# Intel<sup>®</sup> StrongARM<sup>\*</sup> SA-1111 Microprocessor Companion Chip

Specification Update

*March 2000*

Order Number: 278260-008

Figure 2-1. SA-1111 Block Diagram

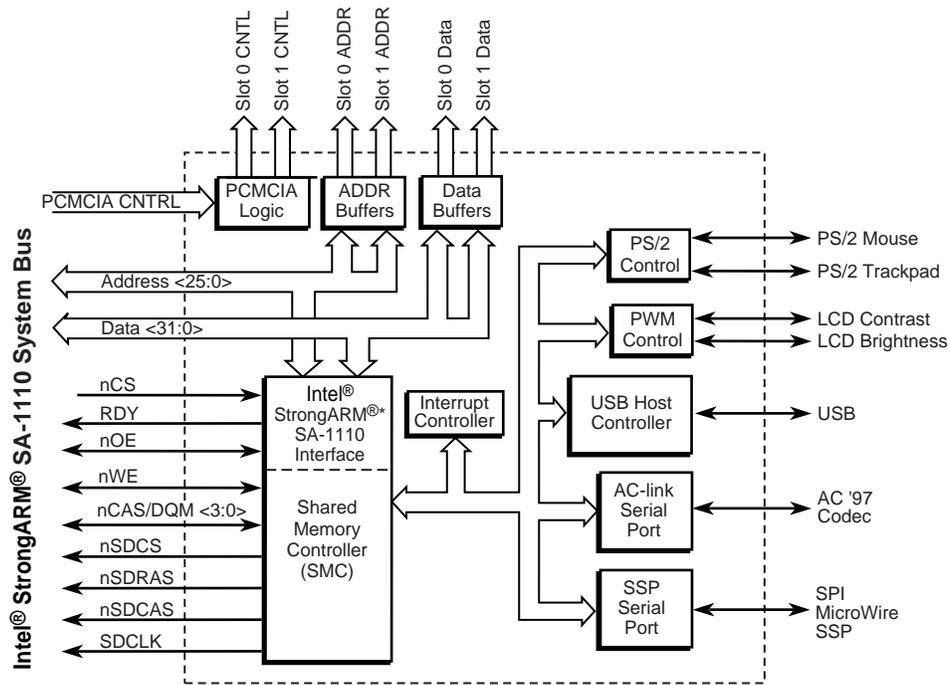
Changed the signal nOE in Figure 2-1 from an input to a bi-directional arrow. Figure 2-1 now appears as follows:

**Figure 3-7. SDRAM Read Cycle, Burst of 2 - CAS Latency = 3**

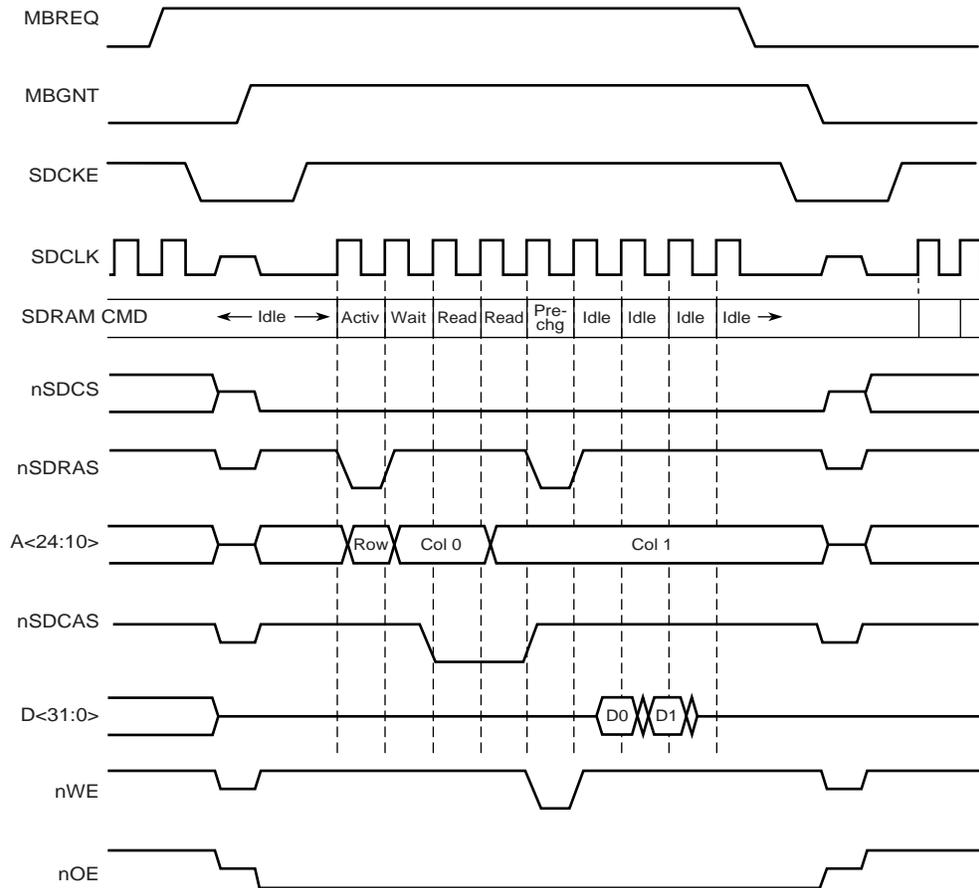
Signal nOE added to bulleted list, added text to this section, updated Figure 3-7 and Figure 3-8. This section now appears as follows:

The SMC also drives signal nOE during DMA transfers. The behavior of nOE is programmable for use in systems with different bus architectures. The nOE behavior may be enabled or disabled. For example, a design may limit system bus loading by placing buffers and transceivers between the SA-1110 (with its system memory) and other peripherals, including the SA-1111. For DMA cycles, the SA-1111 must move data through the transceivers in either direction, depending on whether it is a read or write transfer. Signal nOE may be used to control transceiver direction if it is enabled. When enabled, it is asserted low on reads to SDRAM, and remains high for writes.

Figure 4-1. Decoder Block Diagram

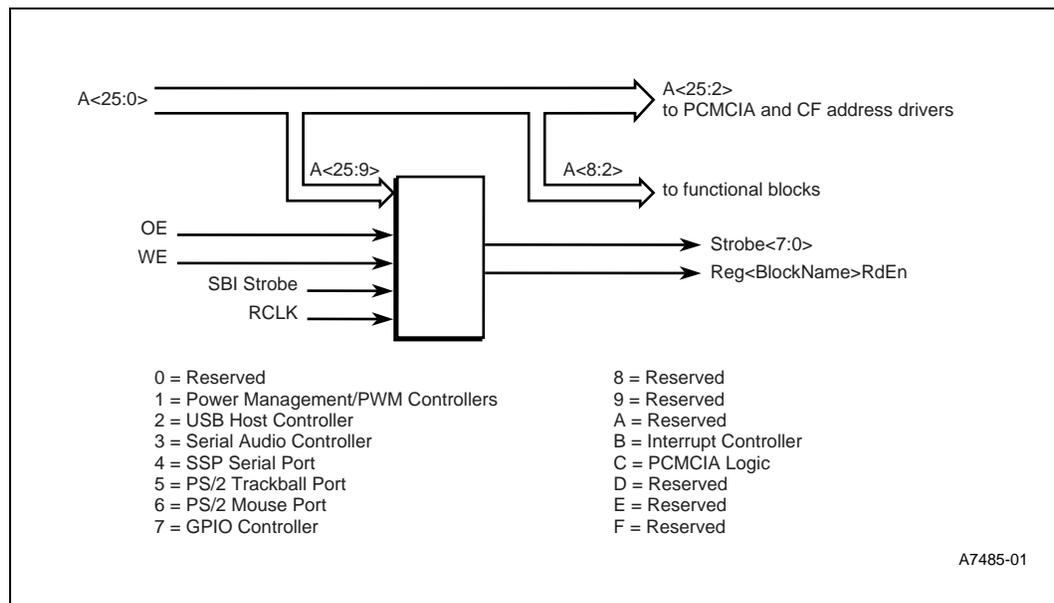
Updated address assignments in Figure 4-1. Figure 4-1 now appears as follows:

**Figure 7-4. MSB-Justified Data Formats (16 bits):**

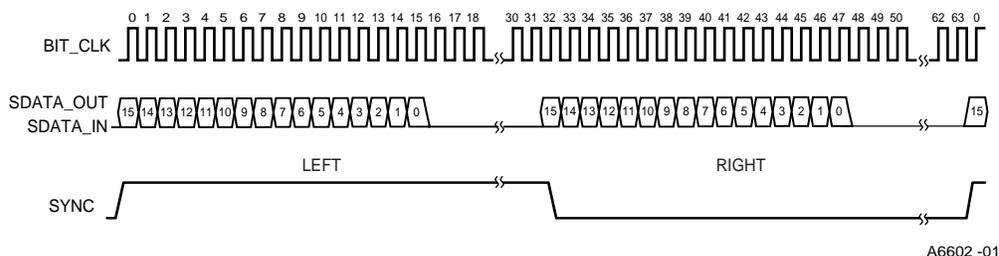
Update Figure 7-4 MSB-Justified Data Formats (16-bits). Figure 7-4 now appears as follows:
